The County of San Diego

Planning Commission Hearing Report

Date:	July 22, 2022	Case/File No.:	Rugged Solar
Place:	County Operations Center 5520 Overland Avenue San Diego, CA 92123	Project:	Major Use Permit Modification and Time Extension for a Solar Facility
Time:	9:00 a.m.	Location:	Ribbonwood Road and McCain Valley Road
Agenda Item:	#5	General Plan:	Rural Lands (RL-80)
Appeal Status:	N/A	Zoning:	General Rural (S92) and A72 (General Agricultural)
Applicant/Owner:	Rugged Solar LLC	Community:	Mountain Empire (Boulevard)
Environmental:	CEQA Guidelines § 15162 through 15164 Addendum	APN:	611-060-04, 611-090-02, 611-090-04, 611-091-03, 611- 091-07, 611-100-07, 612-030- 01, 612-030-19, 611-110-01

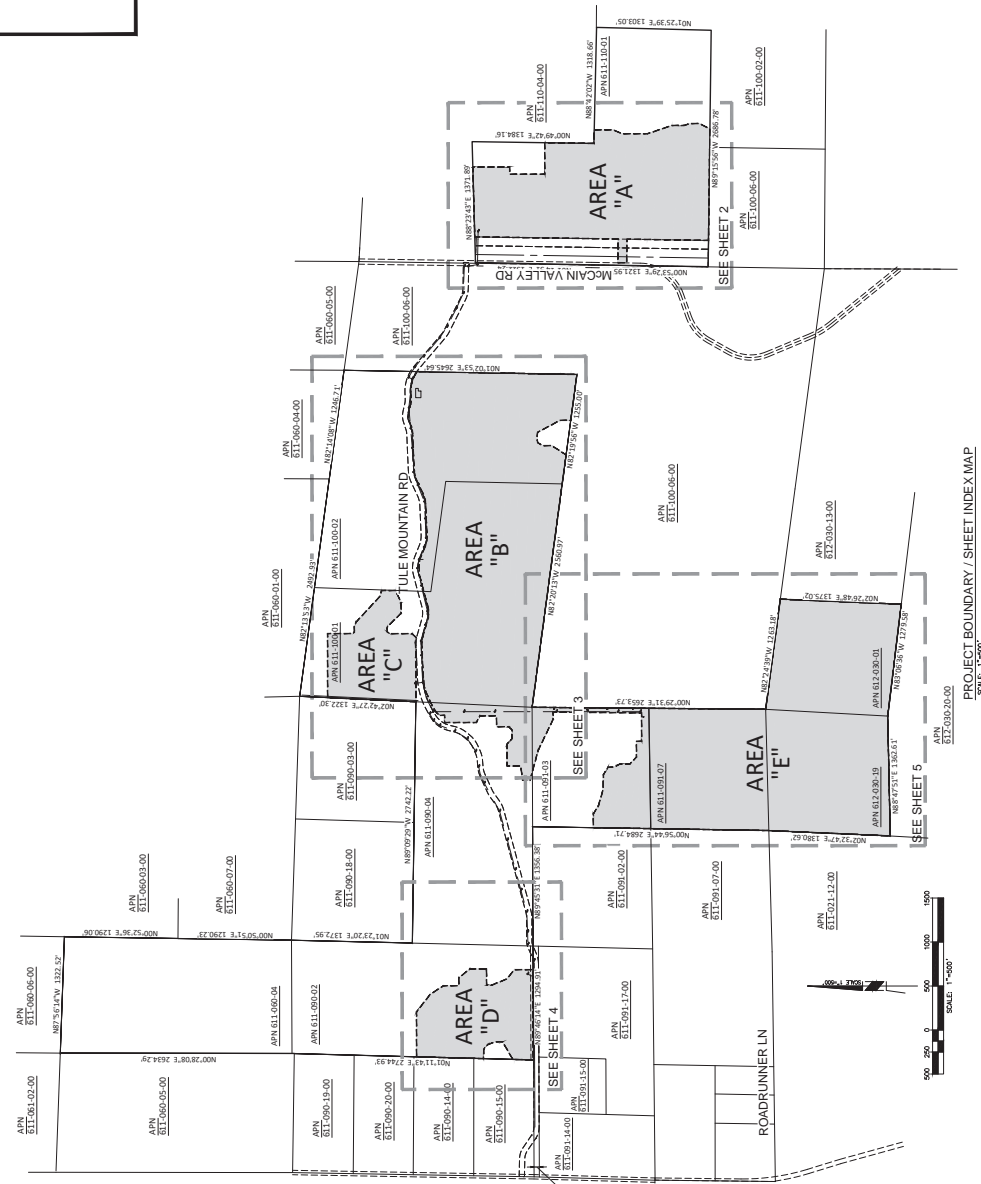
residents living on McCain Valley Road and Ribbonwood Road that both run north to south, runs east to west through the Rugged Solar project itself. See Grading plan at Sheet 1 of 5.²⁵

- **Sheet 1 of 5:**
 - 391.5 acres of 763.35 acres will be cleared and grubbed.
 - That will release lots of stored carbon. Has that been addressed in the Revised PEIR Addendum?
 - “Quantities shown do not include site preparation / clear and grub or utility trench spoils.”
 - MAX CUT SLOPE HEIGHT: 14 FT.
MAX CUT SLOPE RATIO: 2:1
MAX FILL SLOPE HEIGHT: 7 FT.
MAX FILL SLOPE RATIO: 2:1
MAX VERTICAL DEPTH OF CUT: 32 FT
MAX VERTICAL HEIGHT OF FILL: 8 FT.

A subset of the "San Diego Least Cost" site selection figure (Figure 2.10) from the RDF Technical Report. The main map (left) is centered on Boulevard, CA to show a closer view of the CPAs in the surrounding area.

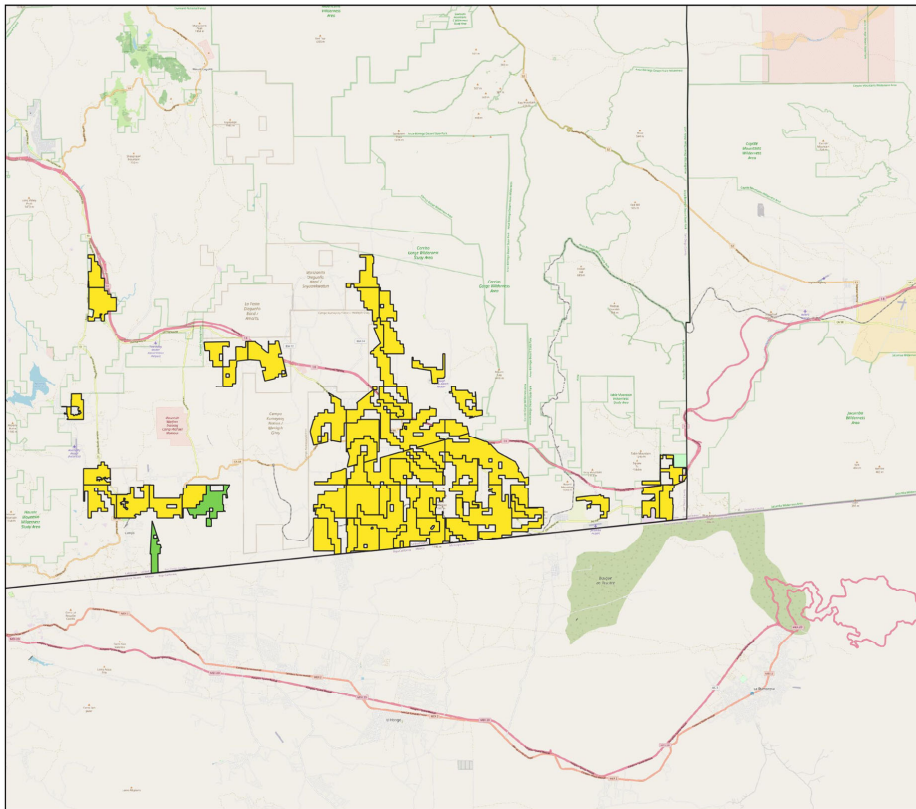
13. Regional Decarbonization Framework¹⁸: See RDF Technical Report Figure 2-10 (same as 2.13) (attached), that targets virtually all of the Boulevard Planning Area as "San Diego" Least Cost of Energy. It throws us under the renewable energy bus despite the fact that we do have lots of prime soils and carbon sequestering chaparral and oak woodlands.

- **VCE Rugged Solar PPA Breach: Rulemaking 18-07-003:** BEFORE THE CPUC: MOTION OF VALLEY CLEAN ENERGY ALLIANCE TO UPDATE ITS DRAFT 2020 RENEWABLES PORTFOLIO STANDARD PROCUREMENT PLAN - dated August 12, 2020
- **RDF Figure 2.10:** map of Boulevard focused LCOE /wind and solar

C-69 The comment notes two attachments to the comment letter, including, “VCE Rugged Solar PPA Breach: Rulemaking 18-07-003: BEFORE THE CPUC: MOTION OF VALLEY CLEAN ENERGY ALLIANCE TO UPDATE ITS DRAFT 2020 RENEWABLES PORTFOLIO STANDARD PROCUREMENT PLAN” and “RDF Figure 2.10: map of Boulevard focused LCOA/wind and solar.”
